Service Note				
Product	Description:	Service note no.		
Wizard	Corrupted characters in the display	720 10 1736

PLL board PC12903-3 and PC12903-4:

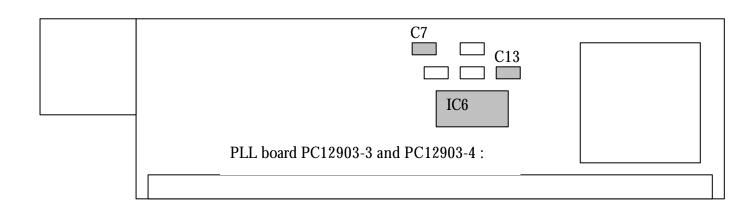
Due to a slow drive in the clock circuit on the PLL board we have experienced corupted

characters in the display

We have to change 3 components in the clock circuit (IC6, C7 and C13 on PLL board PC13903-3 and PC12903-4).

We have to change 3 components in the clock circuit (IC6, C7 and C13 on PLL board PC13903-3 and PC12903-4).

Fra/from	Til/to
IC6	Fairchild 74HC00	Texas 74AHC00
C7	33pF, 0805, 5%, NP0	56pF, 0805, 5%, NP0
C13	47pF, 0805, 5%, NP0	56pF, 0805, 5%, NP0
